STRONG MINING COMPANY

Please see the following comments and answers to your TR-1 Adequacy Review letter.

Apex Mine M-2014-011 Seed Mix TR-1

WATERBAR DETAILS

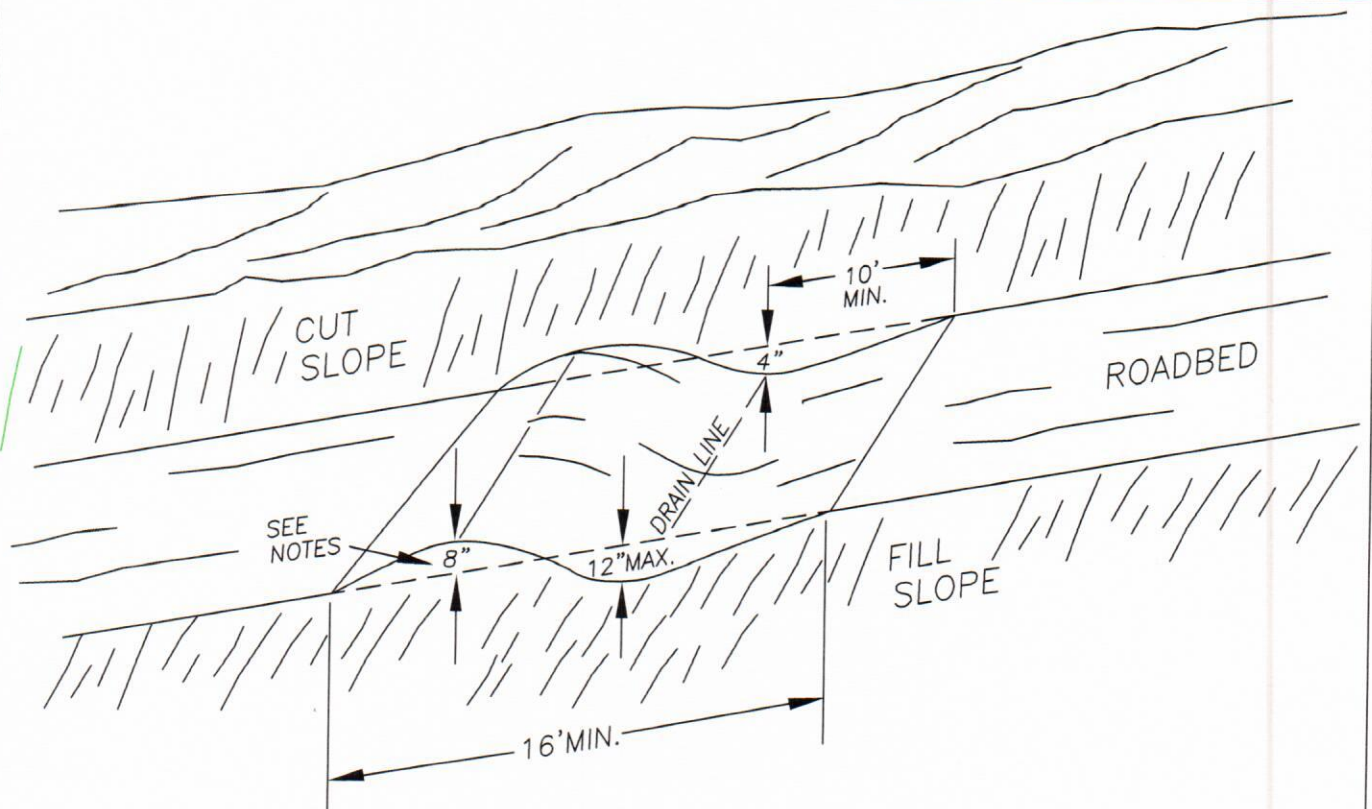
For paragraph #1 please see attached letter from our seed supplier. As for water bars there will be 2 constructed as per F/S. Work will be done using a mid-size tractor. Material to be native soil on site. For volume there will be around 3 yards each. Please see attached plan from F/S. Work will be done in one 8-hour day. And for the Volume of logs in the cabin there is 16 at 24' and 16 at 16'. They will be cut into manageable lengths and scattered per F/S. The work will take around 64 total man hours.
